Project Name: Replace Roofs (Program Phase 1 - 4)

Title: Roof Replacement - Phase 1 Facility B

RFI#: 005

22-090 CIM Replace Roofs Phase 1 – RFI 005 Comments

Fig. 1 Snippet from original construction drawings showing area of Unit 2 in question.

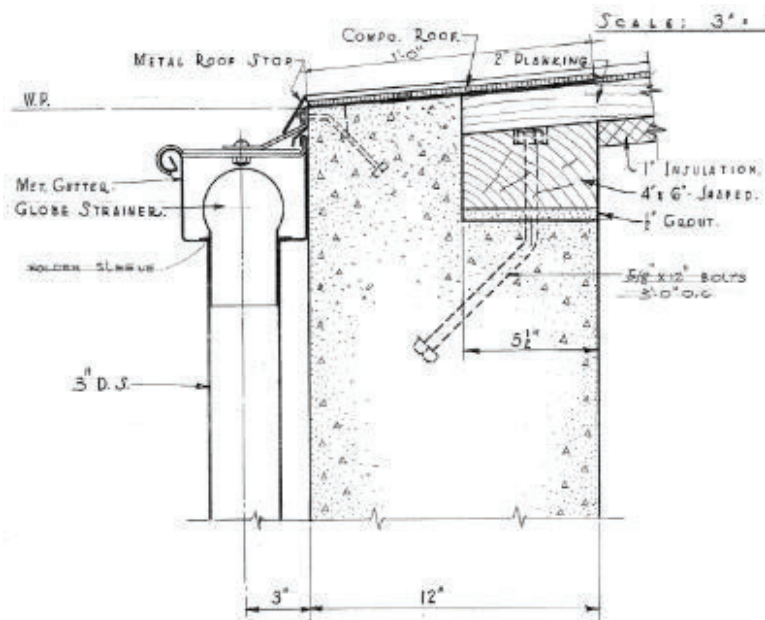
CCM field verified existing conditions plan sheet A2.5-A3.6 Detail #2 shows 2" planking, 1" insulation is deteriorated and does not occur in existing conditions, only composite roof, saturated material, mastic and concrete substrate. See attached photos. Please advise.

I concur with your field findings. Original construction drawings indicate that there are 2 different conditions -one condition with 2" wood planking/substrate and another with 1" insulation over concrete deck/substrate. Per the original construction drawings, the 1" over concrete condition occurs at the area identified by CCM with this RFI. A new detail showing the 1" of insulation over concrete will be created and published as part of an upcoming CB. See my notes attached.
